Access Compliance Report

Public Rights-of-Way

(Curb Ramps)

Intersection ID: 53899	Main Street: LANGWELL_LN	Cross Street: ELGIN_MOOR_RD	Location: NW
ADA ID: E74E2D5517AD	Ramp Type: BlendTrans1	Initial Pass/Fail: Fail	Overall Compliance: No
		Severity Score: 10

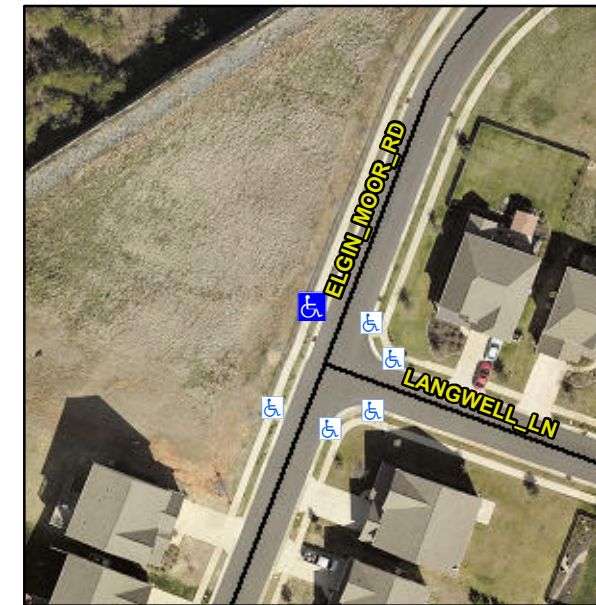
Not Found, R304.5.1, R304.5.3

Compliance	Description	Data	Compliance	Description	Data
N/A	Ramp Length (in)	48.0	Yes	BlendTrans Slope (%)	3.3
No	Ramp Width (in)	47.0	No	BlendTrans XSlope (%)	3.6
N/A	Flare Type LT	N/A	N/A	Flare Type RT	N/A
N/A	Flare Slope LT (%)	N/A	N/A	Flare Slope RT (%)	N/A
N/A	Flare Traversable LT?	N/A	N/A	Flare Traversable RT?	N/A
N/A	Landing Length (in)	N/A	N/A	DWS Provided?	N/A
N/A	Landing Width (in)	N/A	N/A	DWS Contrast?	N/A
N/A	Landing Slope (%)	N/A	N/A	DWS Length (in)	N/A
N/A	Landing X Slope (%)	N/A	N/A	DWS Full Width?	N/A
N/A	Landing Curb? (Y/N)	N/A	N/A	DWS Offset (in)	N/A
N/A	Shared Landing?	N/A			
N/A	Gutter Ponding?	N/A	N/A	Gutter Slope (%)	N/A
N/A	Gutter Lip Ht (in)	N/A	N/A	Gutter X Slope (%)	N/A
N/A	Painted X Walk1?	No	N/A	Painted X Walk2?	N/A
	X Walk 1 Direction	To E		X Walk 2 Direction	N/A
	X Walk 1 Width (in)	N/A		X Walk 2 Width (in)	N/A
	X Walk 1 Slope (%)	1.2		X Walk 2 Slope (%)	N/A
	X Walk 1 X Slope (%)	1.7		X Walk 2 X Slope (%)	N/A

N/A	Ramp inside XWalk1?	N/A	N/A	Ramp inside XWalk2?	N/A
	Road Slope (%)	1.7		Clear Space?	N/A
	Road X Slope (%)	1.2	N/A	Clear Space to XWalk (in)	N/A
N/A	Any Obstructions?	N/A	N/A	Storm Grate/Utility Hazard?	N/A
	Obstruction Type			Storm Grate/Utility Type	
		N/A			N/A
			Yes	Surface Condition? (G/P)	Good
			No	Curb Slope (%)	8.6

Remove & Replace Curb Ramp With Two New Directional Ramps or Equivalent.
